Foundation Investigation
Proposed County Road Underpass
North of Ridgetown, WP 87-59.

FOUNDATION INVESTIGATION
PROPOSED COUNTY ROAD UNDERPASS
NORTH OF RIDGETOWN, ONT.:WP 87-59

RE; W.P. 87-59 Howard Twp.
Bridge #6 Highway #401.

Re: Proposed County Road Underpass
North of Widgetown, District 1,
W.P. 87-59.

BOREHOLE LOCATION PLAN SCALE 1"=100'

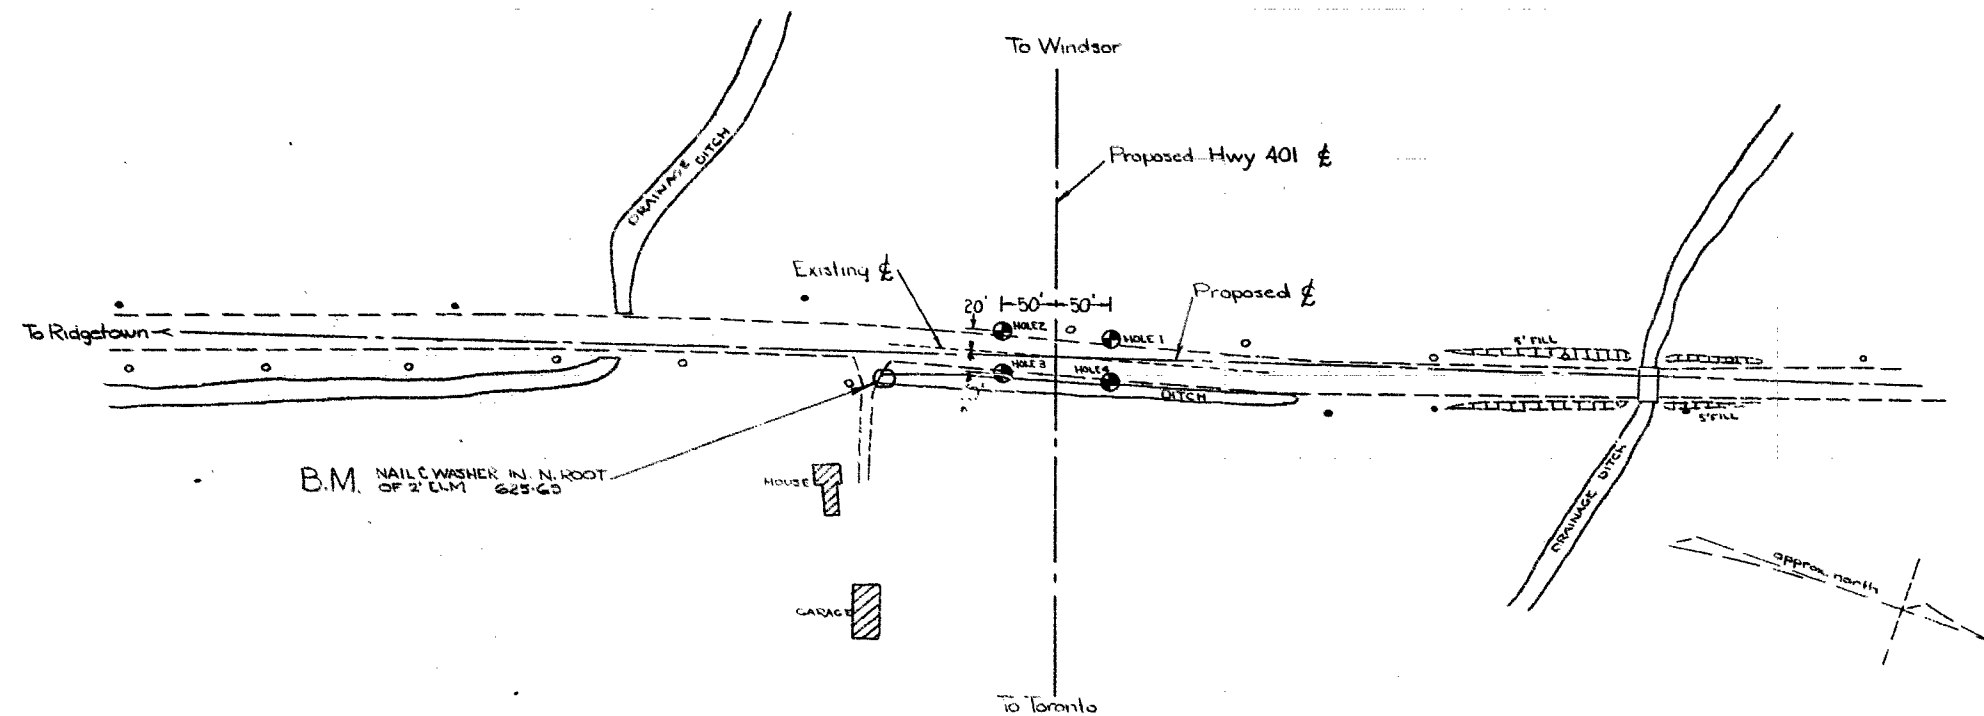
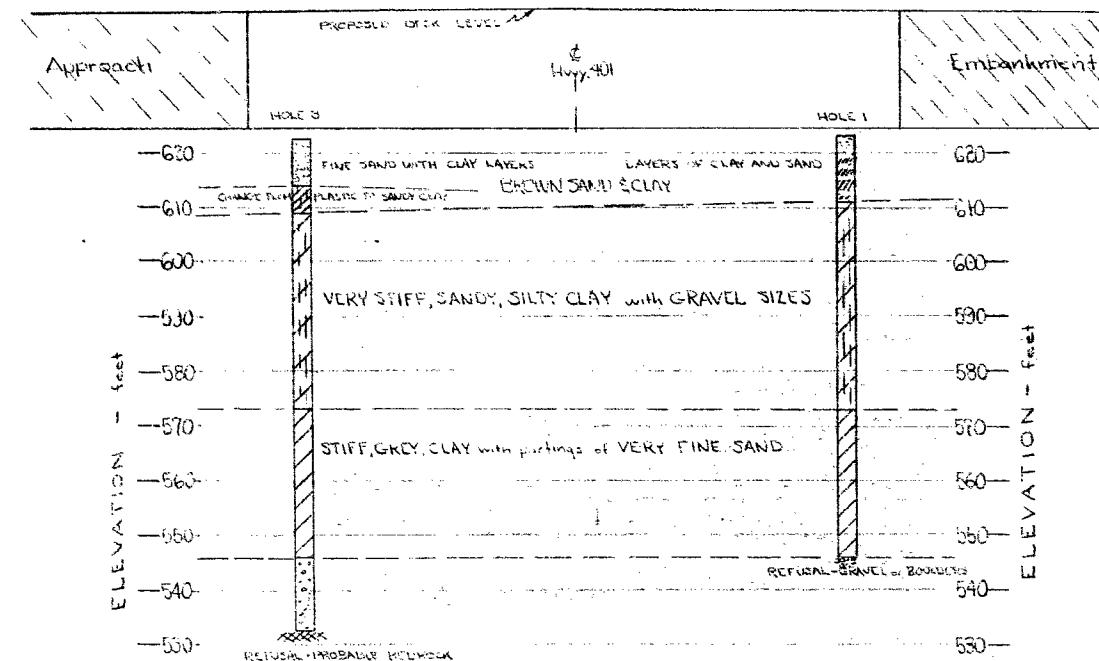
The soil conditions at this site were determined by two borings taken to refusal 77 feet or more below ground surface and by two shallower holes. The soil types encountered at each test location are indicated in the borehole logs, Dwg. 2 to 5 of this report. The stratigraphical profile, shown in Dwg. 1, can be considered to be more or less representative of the materials that underlie the County road intersection. A brief description of each stratum follows.
